USSN 10/042,237
Art Unit 2644

Amendments to the Drawings

App No. 10/092,231;
Att. Unit: 2684**FIG. 3**

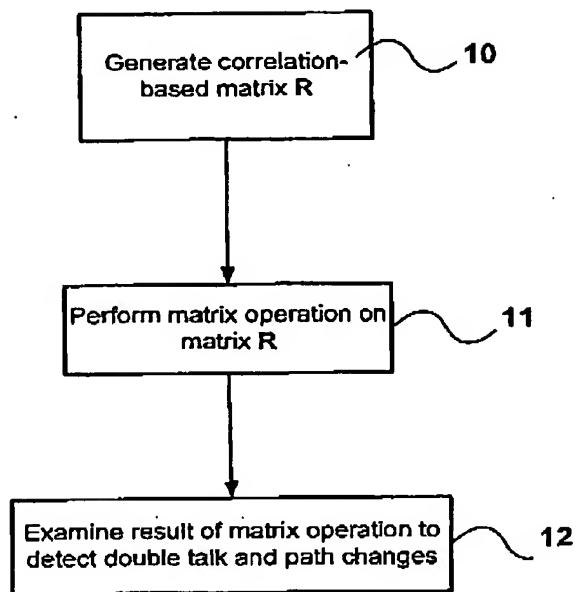
Permission is respectfully requested to replace the sheet of drawings containing Figure 3 on file with the replacement sheet submitted herewith. The newly added subject matter has been deleted in box 12 and replaced by wording taken from the specification.
